# Responses to CEC Data Requests Set Two (30-Day Extension)

Amended Application for Certification  
for  
**HYDROGEN ENERGY CALIFORNIA**  
(08-AFC-8A)  
Kern County, California

**RESPONSES TO DATA REQUESTS (30-Day Extension)  
FROM CALIFORNIA ENERGY COMMISSION (CEC)**

Source: ESRI, USGS seamless 1:24K topo maps. Updated by ESRI, 2009

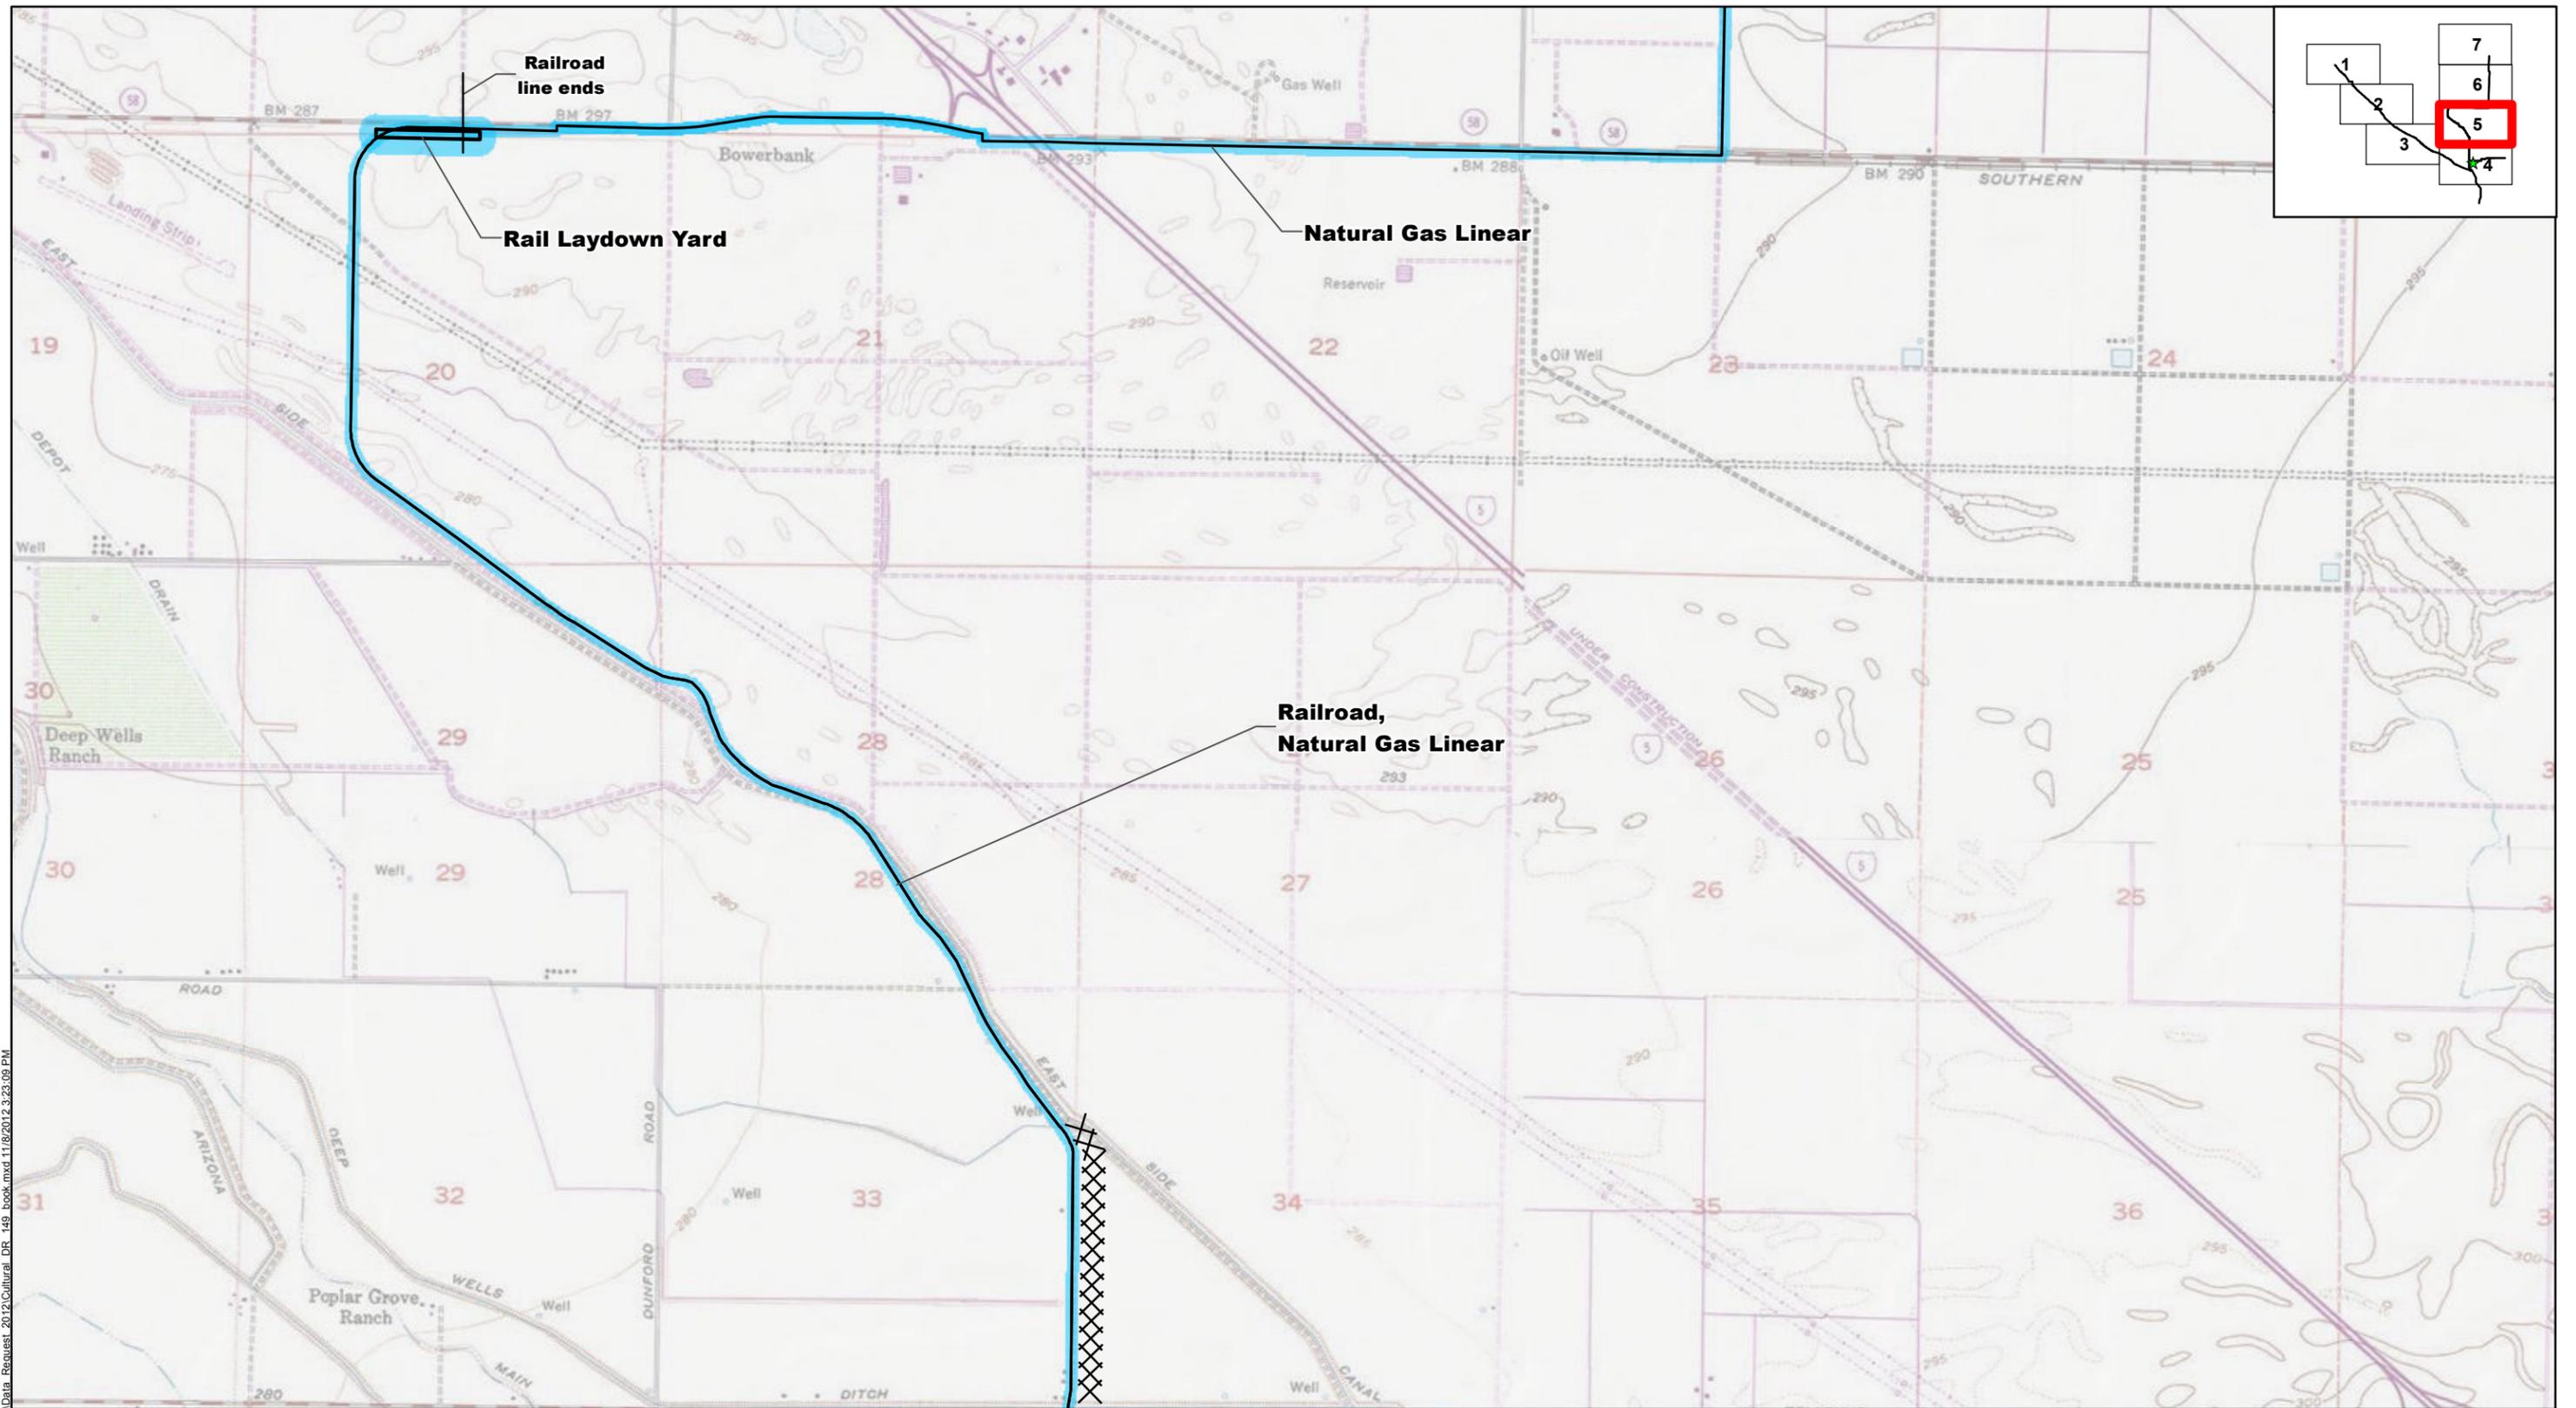
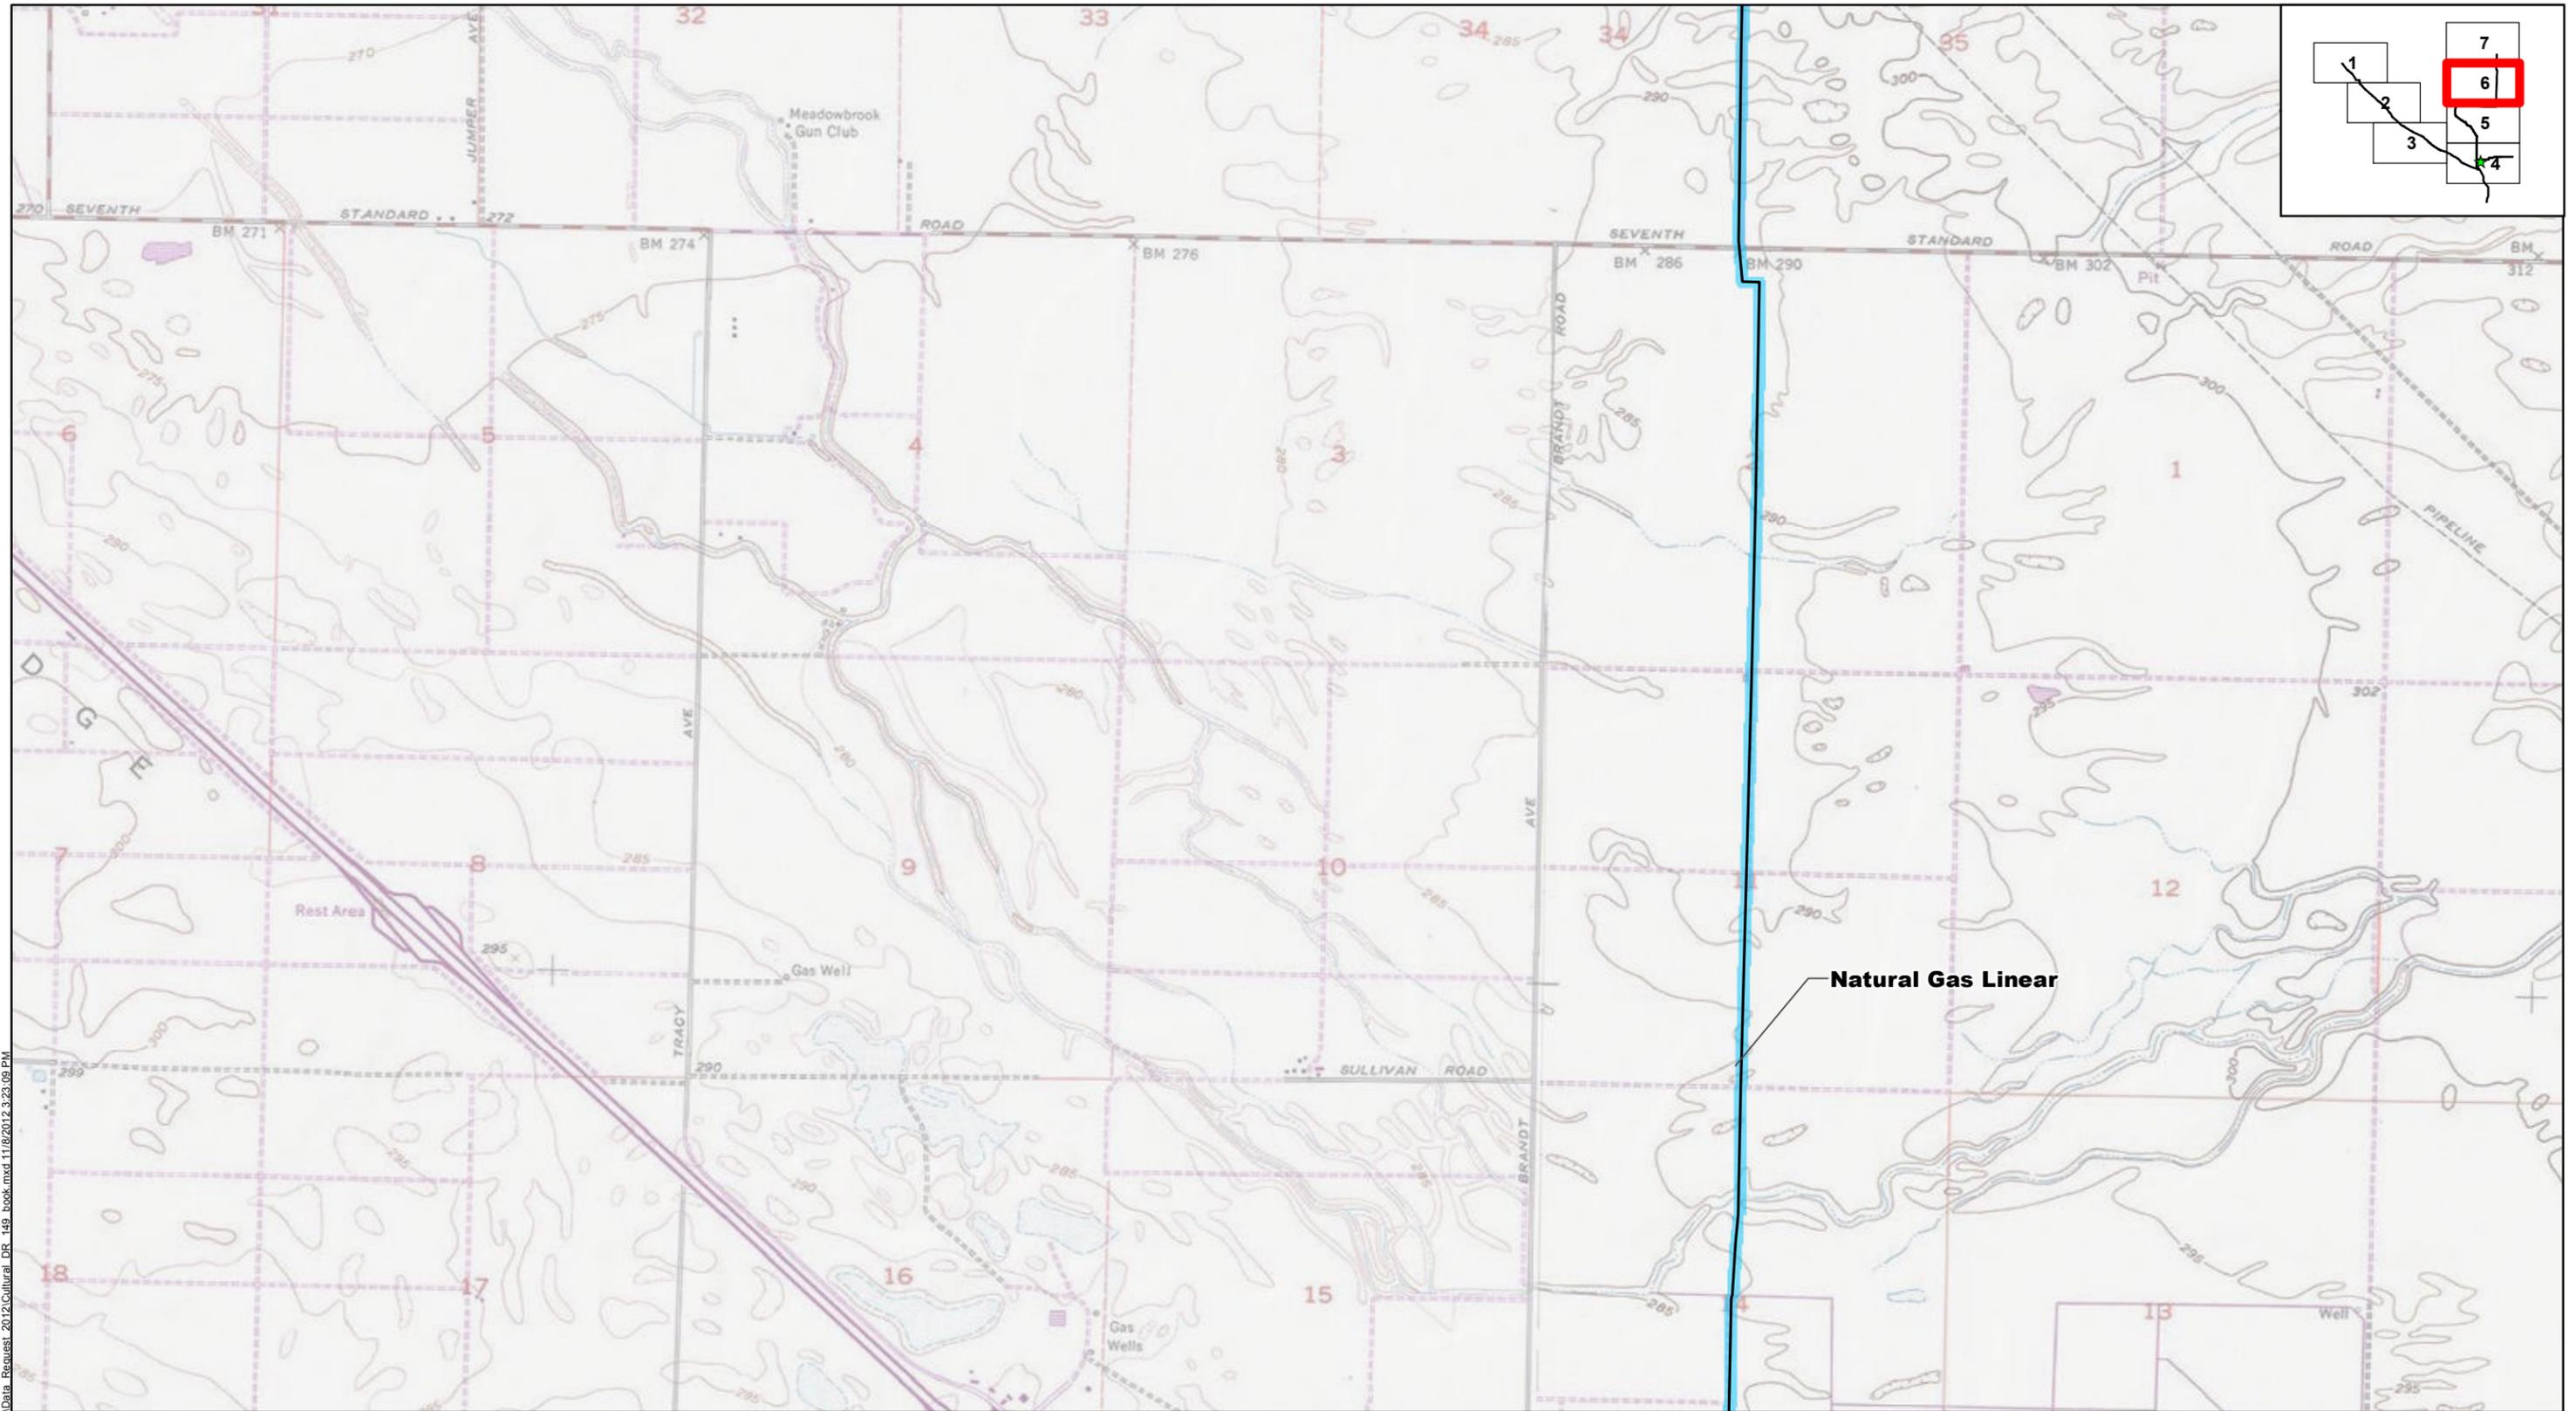
***A149. Please provide survey coverage figures on a 7.5-minute topographic quadrangle base (set at 7.5-minute scale). The figures must include all project elements and boundaries of the areas actually surveyed.***

Figure A149-1 has been updated to accurately reflect all unsurveyed areas to date; it replaces Figure A149-1 (Sheet 4), previously submitted with the responses to CEC Data Requests Set 2. The unsurveyed areas presented on Revised Figure A149-1 also update this element of the following figures previously submitted to the CEC:
